# Access Compliance Report

### (Pedestrian Signals)

Intersection ID: N/A	Main Street:	Cross Street: N/A	Location: N/A
ADA ID: A1A19A9DC538	Signal Type: One Push Button-Non APS	Overall Compliance: No	Severity Score: BTN 1: N/A BTN 2: N/A No BTN: N/A
Codes/Mitigation Info/Possible Solution		Field Measurements/Component Compliance

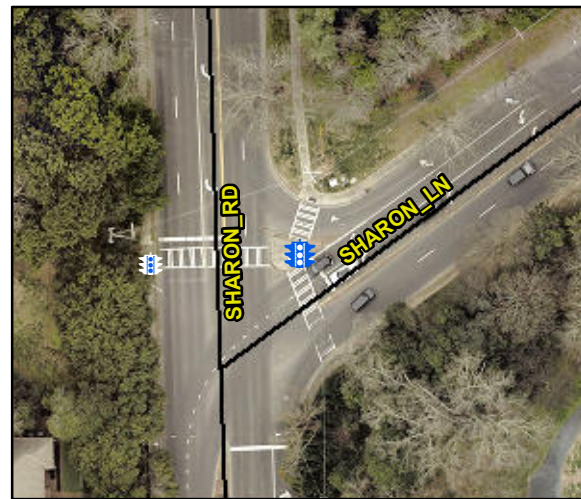
PROW/ADA: TMUTCD 4e.08, R404.1, R404.7.1, R404.7.2

N/A	B 1 FWD Approach Width (in)	N/A	N/A	B 2 FWD Approach Width (in)	N/A
N/A	B 1 FWD Approach Obstruction?	Yes	N/A	B 2 FWD Approach Obstruction?	N/A
N/A	B 1 FWD Approach Obstruction Dist (in)	N/A	N/A	B 2 FWD Approach ObstructionDist (in)	N/A
No	B 1 PARA Approach?	No	N/A	B 2 PARA Approach?	N/A
N/A	B 1 PARA Approach Constrained?	N/A	N/A	B 2 PARA Approach Constrained?	N/A
N/A	B 1 PARA Approach Reach (in)	N/A	N/A	B 2 PARA Approach Reach (in)	N/A
N/A	B 1 PARA Approach Width (in)	N/A	N/A	B 2 PARA Approach Width (in)	N/A
N/A	B 1 PARA Approach Obstruction?	N/A	N/A	B 2 PARA Approach Obstruction?	N/A
N/A	B 1 PARA Approach Obstruction Dist (in)	N/A	N/A	B 2 PARA Approach ObstructionDist (in)	N/A
N/A	B 1 Clear Floor Space Slope (%)	2.7	N/A	B 2 Clear Floor Space Slope (%)	N/A
N/A	B 1 Clear Floor Space XSlope (%)	2.5	N/A	B 2 Clear Floor Space XSlope (%)	N/A
N/A	B 1 PAR Slope (%)	0.9	N/A	B 2 PAR Slope (%)	N/A
Yes	B 1 Height (in)	37.0	N/A	B 2 Height (in)	N/A

Yes	B 1 Clear Xing Direction?	ClearlyMarked	N/A	B 2 Clear Xing Direction?	N/A
	B 1 Crossing Direction	To W		B 2 Crossing Direction	N/A
Yes	B 1 DistanceTo XWalk (in)	0.0	N/A	B 2 DistanceTo XWalk (in)	N/A
No	B 1 DistanceTo Curb (in)	193.0	N/A	B 2 DistanceTo Curb (in)	N/A
Yes	B 1 Diameter (in)	2.0	N/A	B 2 Diameter (in)	N/A

Possible Solutions: Replace Signal Push Button With APS Button on New Post. Remove & Relocate Sign.
